ADDENDUM #2

INVITATION TO BID NO: ITB 2022-799

PROJECT: NM173 PHASE 1 WATERLINE RELOCATION

PRE-BID MEETING SUMMARY

TRENCH DETAIL (TYP.). REFER TO MULTIPLE PIPE TRENCH DETAIL (THIS SHEET) FOR MULTIPLE PIPES IN ONE TRENCH.

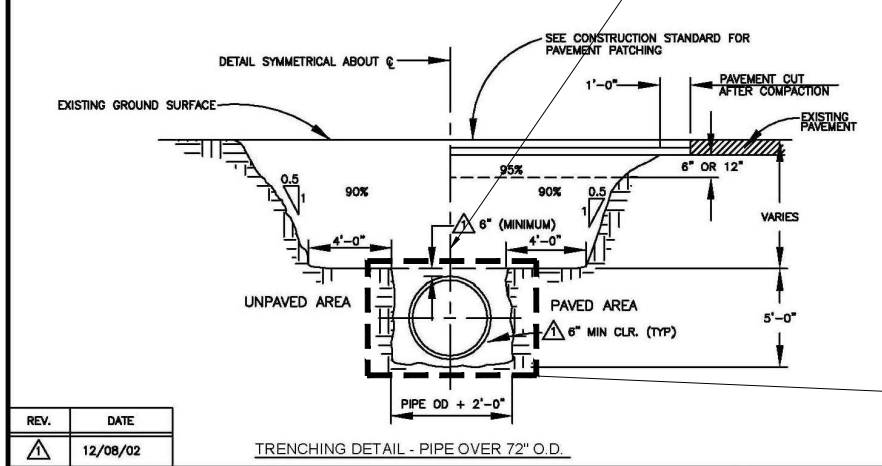
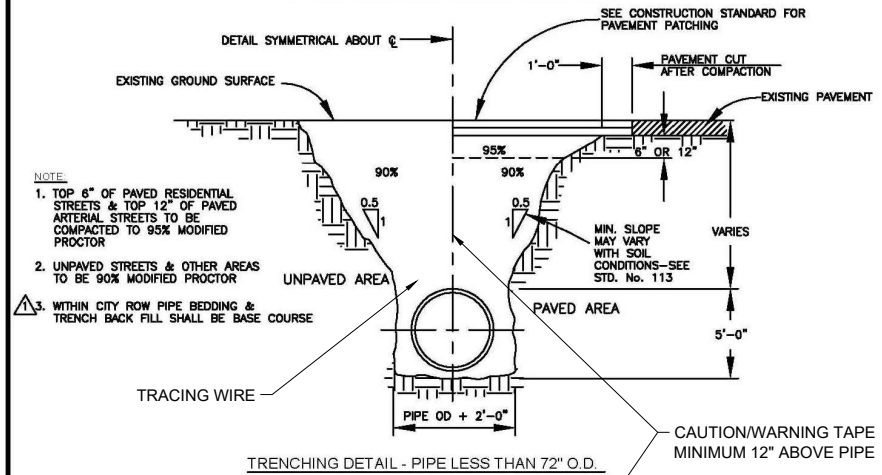
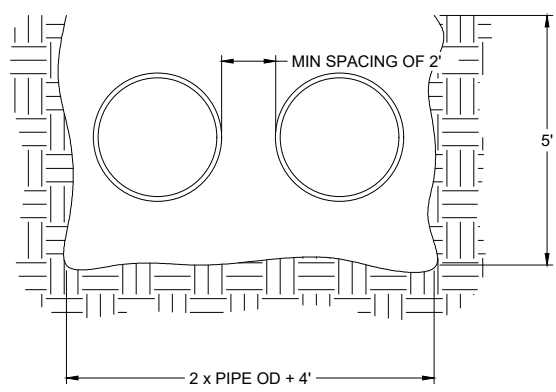
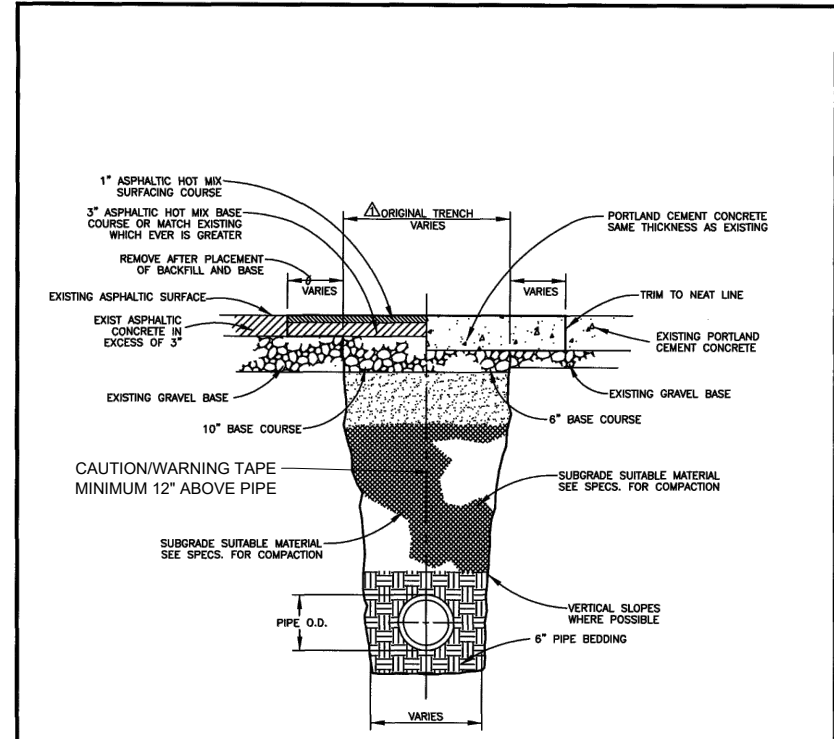
3. Will a traffic control plan be available?
 - a. There is a traffic control plan that was approved by NMDOT just prior to advertisement. A complete set of design drawings with this approved plan and additional pipe trench details is included in Addendum #2.
